MEMORANDUM

To: Development Review Board
From: Mary O'Neil, AICP, Principal Planner
Date: November 2, 2021
RE: ZP21-457; 43 Adams Court

Request: Rebuild north facing dormer and add south facing dormer with 7' ceiling height, rebuild back deck and stairs to code, request for a one space parking waiver for the total number of spaces to 3; remove chimney.

1. Massing, Height and Scale:

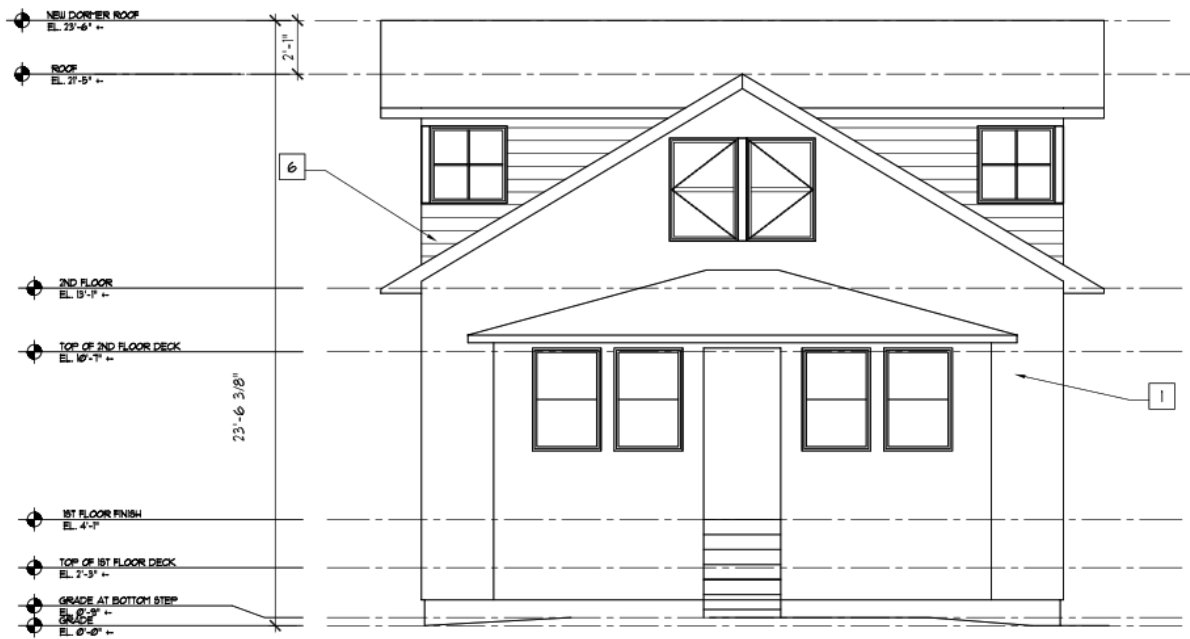
43 Adams Court is among a group of modest Craftsman style bungalows constructed in the 1920s on Adams Court. Two of them have already seen oversized rear additions, completed under different regulations and before the street was listed on the Vermont State Register in 2005. The tendency to pop the roof and create either an oversized addition or roof wings on these characteristically small residences typically negatively affect the historic integrity of the structure; oftentimes at the expense of its inherent design. The applicant has submitted four sets of plans, all with vertical expansion. Version A (below) has been recommended for approval by the Design Advisory Board. **Affirmative finding.**

2. Roofs and Rooflines.

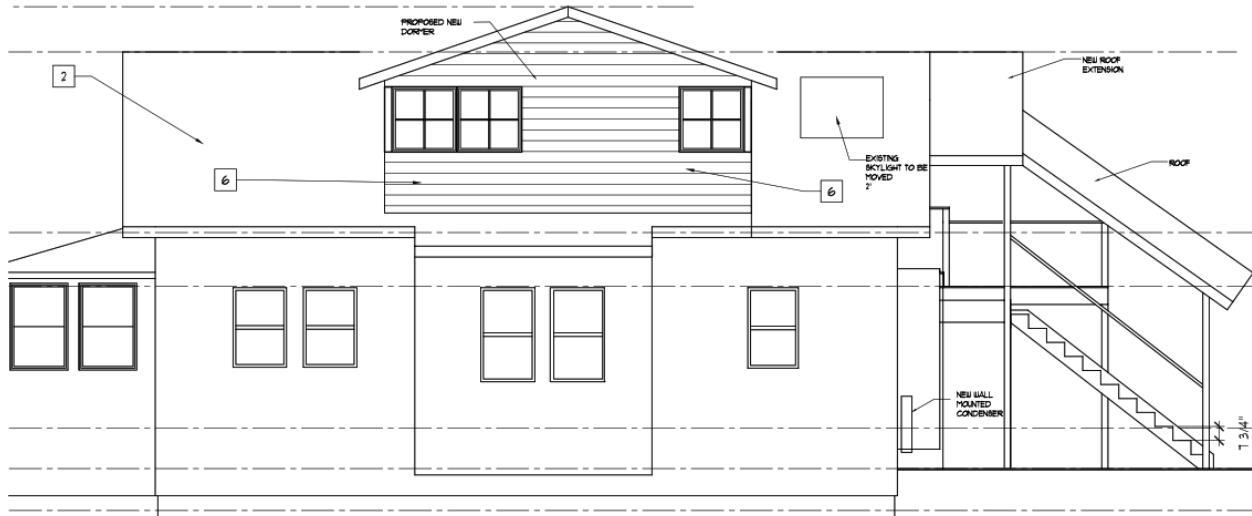
The paired gable-roof saddle dormers have received a recommendation for approval from the DAB. **Affirmative finding.**
